ADDENDUM NO. 1

Request for Proposal # 1246 Parking Lot 60 Expansion

Re: RFI No. 1 - MSA Parking Lot Expansion – 35 Clove Road

CONCRETE HEADWALL

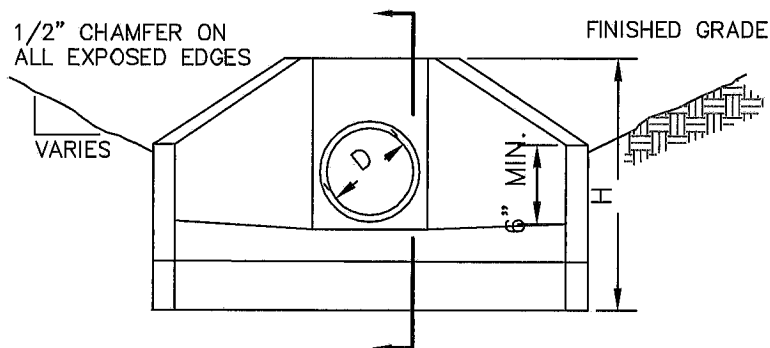
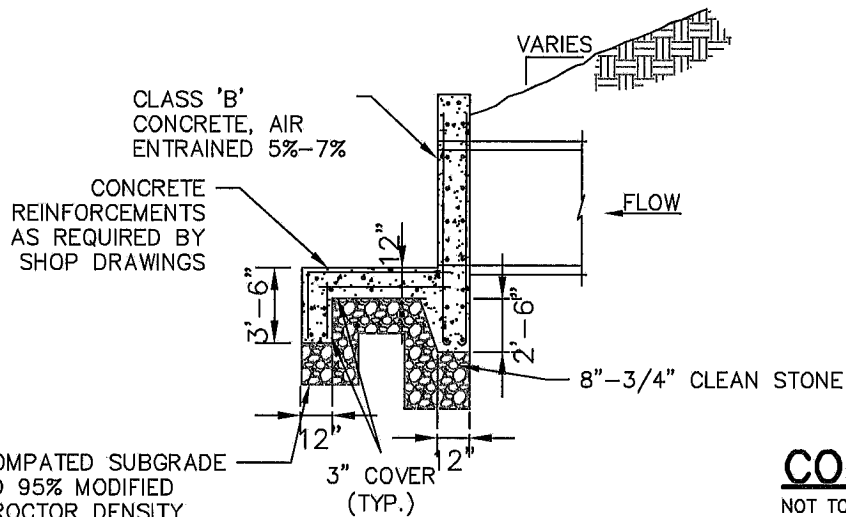
1. On Drawing #C-05 Concrete Head wall shown, we need details for Concrete Headwall on 24" RCP, details for 12'x10' Scour Hole, details for Rip-Rap with details of existing width & side slop of channel.

- (1) A concrete headwall is proposed on sheet C-05 GRADING AND UTILITY PLAN. Concrete Headwall Detail is attached.
- (2) A preformed scour hole is proposed on sheet C-05 GRADING AND UTILITY PLAN. Preformed Scour Hole Detail is attached.
- (3) A riprap channel is proposed on sheet C-05 GRADING AND UTILITY PLAN. The riprap channel shall be constructed out of 3" D50 stone, shall be 6" deep with filter fabric under stone, and shall meet the existing bottom width, bottom slope, and side slopes of existing channel. The contractor is to extend the proposed riprap channel to the end of the existing swale; this distance is approximately 450'.

D	a	A	G	F	H
24"	30"	21"	60"	9'-2"	6'-3"
